Lower Thames Crossing

9.192 Responses to the Examining Authority's Third Written Questions (ExQ3)

DATE: December 2023
DEADLINE: 8

Planning Inspectorate Scheme Ref: TR010032
Examination Document Ref: TR010032/EXAM/9.192

Plate 2 Existing utility networks within Claylane Wood

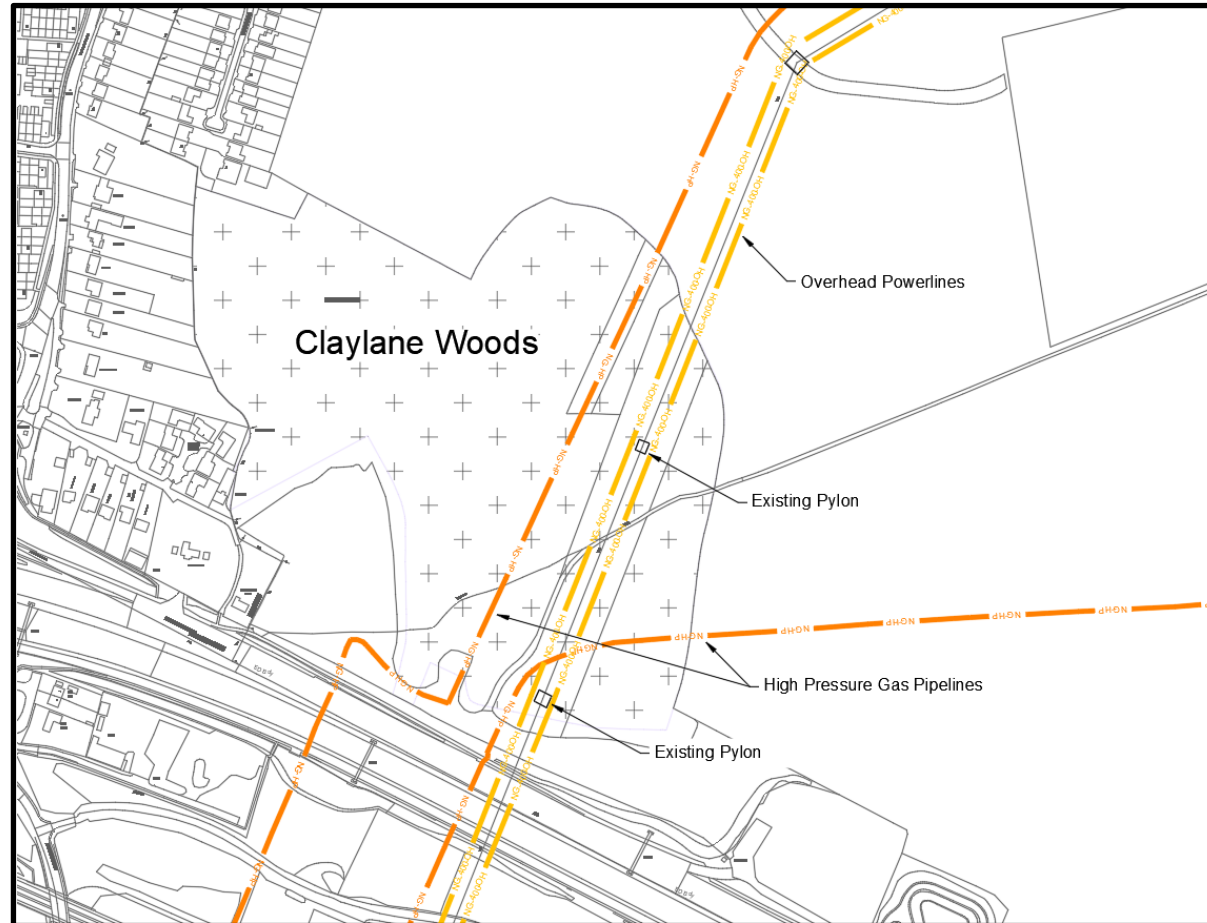
PINS ID	Question to	Question / Response
		<p>The impacts associated with utility works within Claylane Wood, specifically Work Nos OH1, OHT1, G2 and G3, are notably due to the location of the existing networks (see Plate 2 below) which require diverting (see Plate 3 below), and the Applicant's intention is to limit the extent of the works to those networks and the potential impacts associated with them. The alignment of other utility works, Work Nos G1b and MU17, are constrained by their relationship with the proposed highways junction design and the relevant design guidance, standards and legislation, which determine their alignment within and through Claylane Wood.</p>

The Applicant would refer the Examining Authority to item 2.1.2 of the Forestry Commission's SoCG [\[REP4-106\]](#) where the Forestry Commission agrees with the Applicant's assessment that it has considered alternative

Plate 4 Extract from the General Arrangement Plans Sheet 4 [REP7-026]

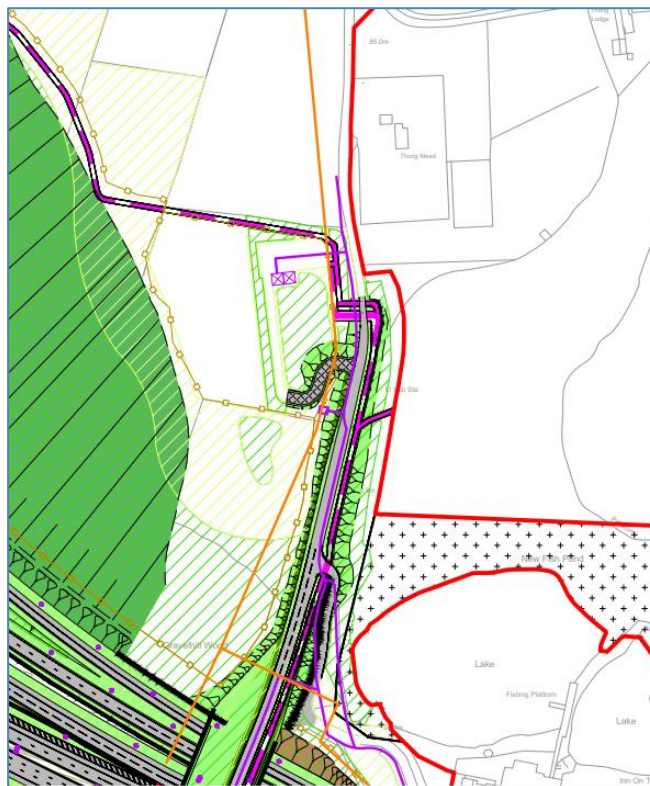
PINS ID	Question to	Question / Response
	<p>Natural England Kent County Council Gravesham Borough Council Shorne Parish Council</p>	<p>Clarification is requested in relation to the proposed car park retention question at Shorne Woods SSSI. The matter was raised at ISH9 and the decision appears to be, as referenced in the transcript [EV-074], and submission [REP6-090], that no carpark is to be retained.</p> <ul style="list-style-type: none"> • Are those bodies listed content that this is the position? <p>The Applicant should also confirm how the land is proposed to be restored after removal of the construction compound and where the restoration proposals are secured.</p> <p>Response:</p> <p>In short, the restoration of the land which was previously proposed as a car park following the end of the construction period is secured under article 35, and Requirement 5, of the draft Development Consent Order [REP7-090].</p> <p>In response to concerns expressed by stakeholders in relation to the potential effects on the provision of additional visitor facilities (as expressed at Issue Specific Hearing 9 (ISH9) and through stakeholder engagement) the Applicant has removed the car park proposals (i.e. Work No. 1P) from the Application. This amendment was notified to the Examining Authority on 8 November (Amendment EA08) and reflected in the Applicant's Deadline 7 submission Deadline 7 Hearing Actions [REP7-185].</p> <p>Removing the car park would enable an area of mitigation planting to be relocated further east (to provide screening of substations SS2 and SS3 and the associated Thong Lane access road) resulting in a circa 5,600sqm area of land changed from requiring permanent acquisition powers to temporary possession of land only, as shown on Plate 4 below. The Applicant does not consider this to be a change to the application; it is an amendment contained to land within the Order Limits with no impact on the assessment of the environmental effects of the Project.</p> <p>Revised General Arrangement Plan Volume B Sheet 4 [REP7-026] shows the amended layout, retaining the proposed substations and access and restoring the remaining construction compound area in accordance with the outline Landscape and Ecology Management Plan [REP7-132] and article 35 of the draft DCO [REP7-090].</p>

As a result of the amendment, Design Principle S2.11 [REP7-140] has been revised to state:
'The substations shall be appropriately sited and designed (materials and colour) to integrate with the surrounding landscape. Planting shall be provided along Thong Lane between the substations within the constraints of proposed utilities and highway visibility splays to the substation access track entrance. Planting shall be designed to the east of the substations to screen views of the substations from Thong Lane and Shorne Woods. Planting shall be designed to the north of the substations to screen the views from the village of Thong. Boundary planting shall be provided to integrate the substations into the surrounding landscape. The
